Access Compliance Report

Public Rights-of-Way

(Curb Ramps)

Intersection ID: 50938	Main Street: BLAIREBETH_ST	Cross Street: CANMORE_ST	Location: SW
ADA ID: 8480CE231A02	Ramp Type: BlendTrans1	Initial Pass/Fail: Fail	Overall Compliance: No
		Severity Score: 12.5

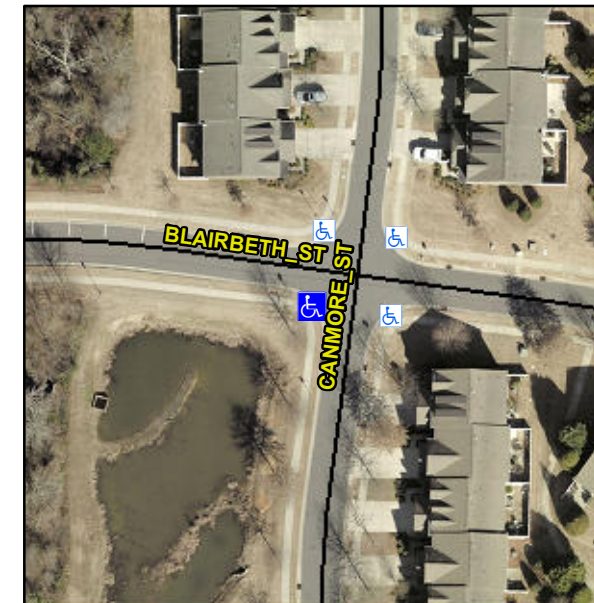
Not Found, R304.5.3

Compliance	Description	Data	Compliance	Description	Data
N/A	Ramp Length (in)	48.0	Yes	BlendTrans Slope (%)	4.6
Yes	Ramp Width (in)	48.0	No	BlendTrans XSlope (%)	6.0
N/A	Flare Type LT	N/A	N/A	Flare Type RT	N/A
N/A	Flare Slope LT (%)	N/A	N/A	Flare Slope RT (%)	N/A
N/A	Flare Traversable LT?	N/A	N/A	Flare Traversable RT?	N/A
N/A	Landing Length (in)	N/A	N/A	DWS Provided?	N/A
N/A	Landing Width (in)	N/A	N/A	DWS Contrast?	N/A
N/A	Landing Slope (%)	N/A	N/A	DWS Length (in)	N/A
N/A	Landing X Slope (%)	N/A	N/A	DWS Full Width?	N/A
N/A	Landing Curb? (Y/N)	N/A	N/A	DWS Offset (in)	N/A
N/A	Shared Landing?	N/A			
N/A	Gutter Ponding?	N/A	N/A	Gutter Slope (%)	N/A
N/A	Gutter Lip Ht (in)	N/A	N/A	Gutter X Slope (%)	N/A
N/A	Painted X Walk1?	No	N/A	Painted X Walk2?	No
	X Walk 1 Direction	To E		X Walk 2 Direction	To N
	X Walk 1 Width (in)	N/A		X Walk 2 Width (in)	N/A
	X Walk 1 Slope (%)	3.2		X Walk 2 Slope (%)	1.7
	X Walk 1 X Slope (%)	2.6		X Walk 2 X Slope (%)	2.7

N/A	Ramp inside XWalk1?	N/A	N/A	Ramp inside XWalk2?	N/A
	Road Slope (%)	3.6		Clear Space?	N/A
	Road X Slope (%)	0.1	N/A	Clear Space to XWalk (in)	N/A
N/A	Any Obstructions?	N/A	N/A	Storm Grate/Utility Hazard?	N/A
	Obstruction Type			Storm Grate/Utility Type	
		N/A			N/A
			Yes	Surface Condition? (G/P)	Good
			No	Curb Slope (%)	9.6

Remove & Replace Curb Ramp With Two New Directional Ramps or Equivalent.
